Near Detector I&I - Assessment meeting at FNAL

Overview of the Near Detector Installation

2024-02-15

Top view of the surface and cavern space

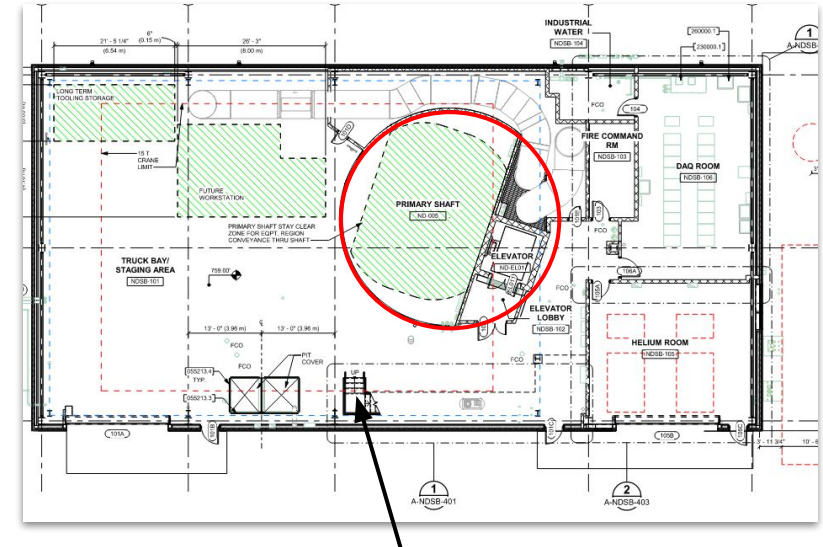
- Shaft Crane may have limited mobility when lowering equipment, due to the design of the crane cables and the crane drum.
 - Crane cables form a v as the crane extends
- Crane capacity is 15 ton, SMEs comment that this is a low capacity in their perspective.
 - Undersized crane are a frequent issue at FNAL
 - SBN had to increase crane capacity for BOTH cranes.
 - SBN 20 -> 23 ton
 - Icarus 2x30 -> 2x33 ton
 - Detector equipment was still in design during building design/construction, and weight estimates grew after detector design matured and exceeded crane capacity.
 - Investigate heaviest objects and their design maturity. Add weight margins proportional to maturity.

Top view of the surface and cavern space

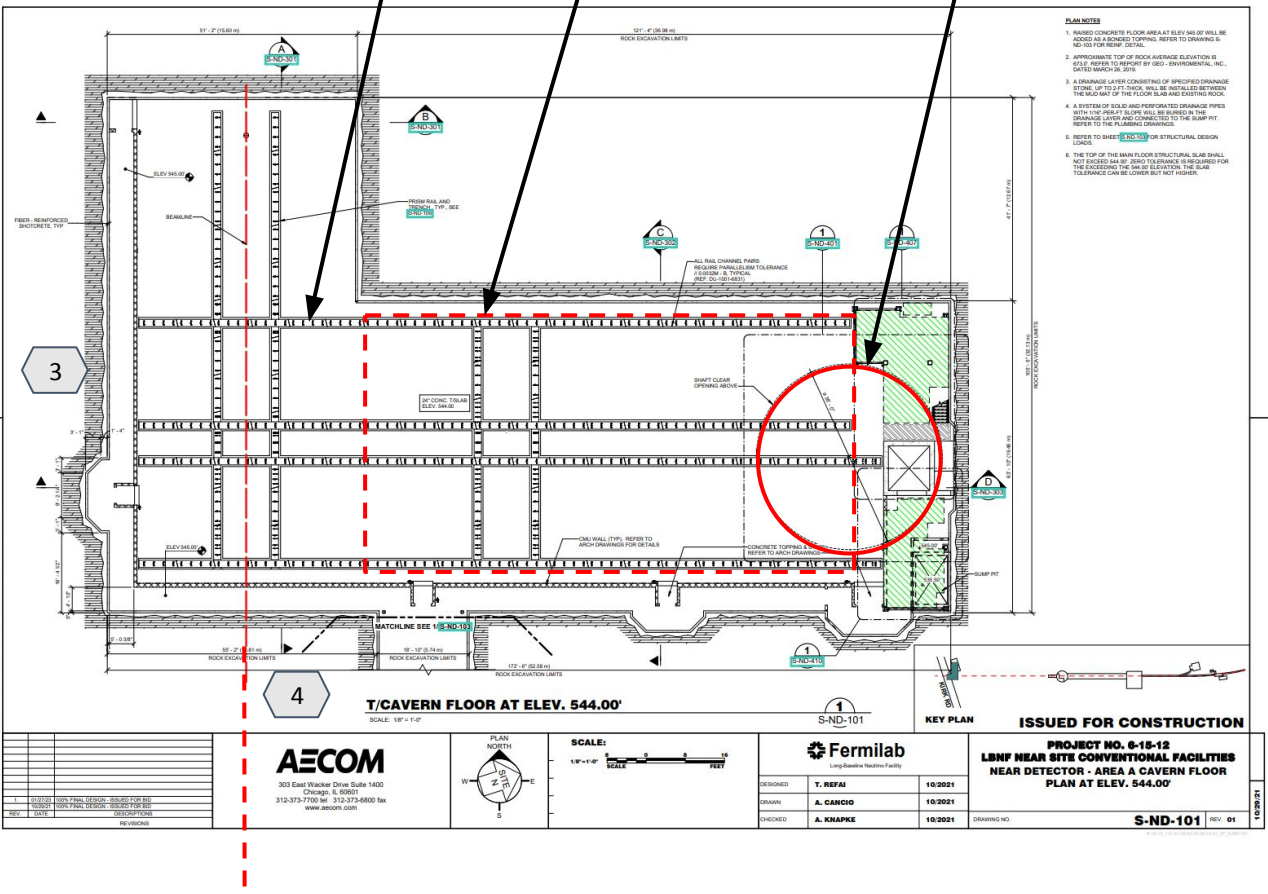
- As crane capacity increases, speed decreases. In the cavern, the 60 ton capacity crane may lead to increased handling times for lighter items.
 - CDF: 50 ton crane with 10 ton aux hook, about 2x increase in vertical lifting speed on low capacity hook.
- Cavern crane coverage does not cover the center of the shaft. This will cause issues with lifting components lowered into the cavern by the surface crane. Need to ensure we can access lowered components with the cavern crane.
 - Cavern crane coverage starts 4' off from the shaft centerline
 - What is the geometrical center of the shaft open space?

Top view of the surface and cavern space

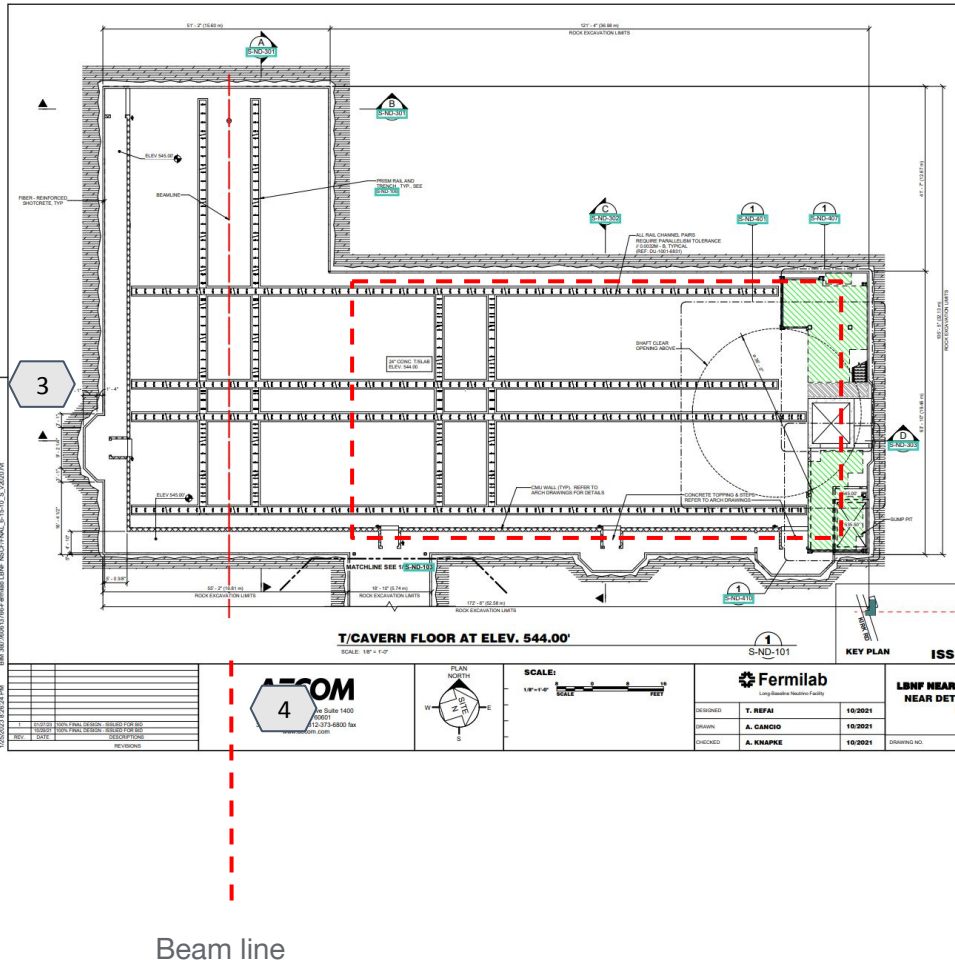
Safety

- What is the clearance zone that needs to be excluded when work is happening in the shaft?
- What precautions need to be taken while shaft cryo work is taking place? Netting on top and bottom?
- DOE imposed an occupancy limit on the MINOS facility that was stricter than the facility requirement. **To be confirmed**
- Work planning and safety coordination need to be tightly coordinated.
 - Detector teams will write a higher level installation procedure, which is then reviewed by technicians who provide input on the work plans, which are then reviewed and approved by safety.
 - Work plans for all installation steps are to be written by/with technicians
 - Work planning should be prepared as far in advance as possible.

Cavern Assembly Layout

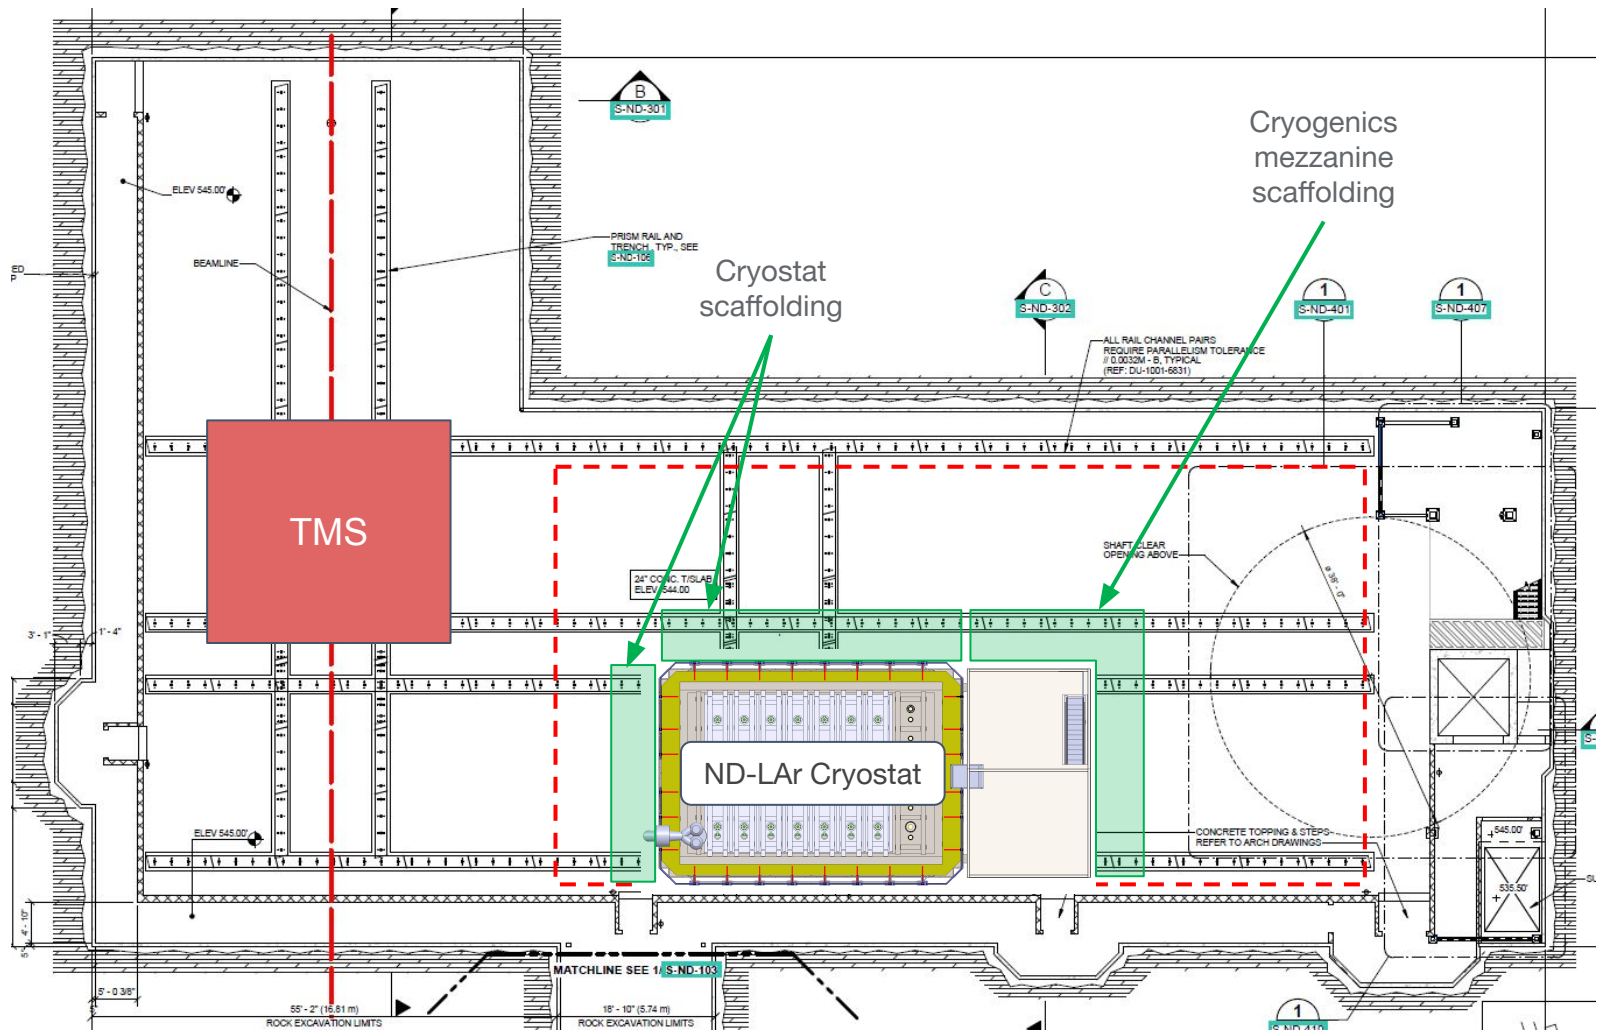
- Consider a gantry for TMS
- Staging of equipment: fixtures to stage equipment for installation?
Reverse order of lowering
- Bundling may decrease the time down the shaft, but will increase the labor down in the cavern.

Rental Equipment

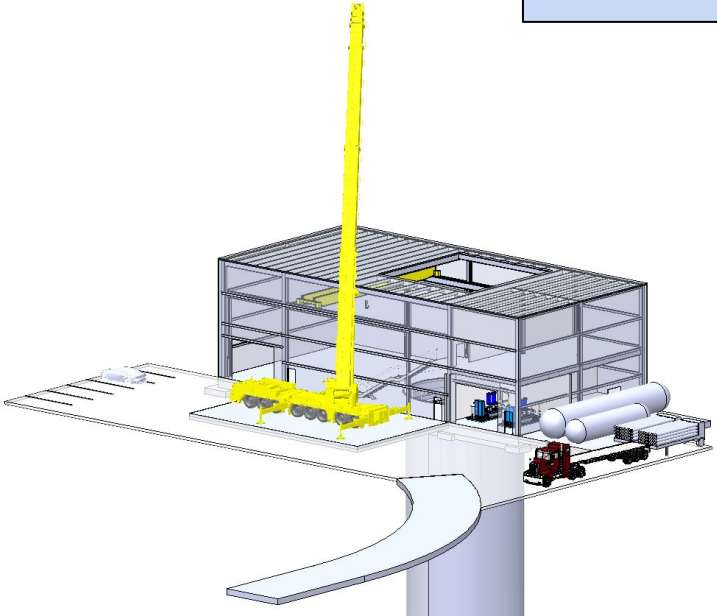
- Some equipment may be available at FNAL:
 - Spreader beams may be available - depending on capacities
 - Slings are “consumables” that wear out over time, we should plan to buy all new ones, perhaps re-buy over the course of the project.
- Lifting equipment needs to be load tested for critical lifts.
 - Almost every lift for ND will be a critical lift.
 - “Critical Lift” framework is somewhat new, so experience on how to operate under this framework is slim.
- Counterbalances lifting beam used on Icarus
- 50A limits on lithium batteries (may require lead-acid batteries?)
- Revisit the requirements for fork trucks. Maybe we can borrow them for shorter durations.
 - Identify in the installation plan what individual steps require each piece of equipment.
 - Scissor lifts and boom lifts are becoming preferable to ladder usage
